WHITE PAPER
ON KNOWN ERRATA ON
SPECIFICATION ARINC 653
(AVIONICS APPLICATION SOFTWARE
STANDARD INTERFACE)

**Prepared by the Application/Executive (APEX)
Subcommittee**

PUBLISHED: September 2021

1.1 Section 2.3.2.2.1.2, Figure 2.3- Process States transitions: Waiting-Waiting transitionProblem Statement:

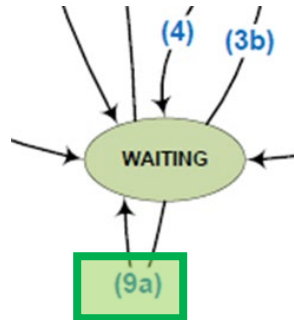
In Supplement 3, the right side Waiting-Waiting transition refers to “(9c)”, not “(9a)”:

In Supplement 4, the right side Waiting-Waiting transition now refers to “(9a)”:
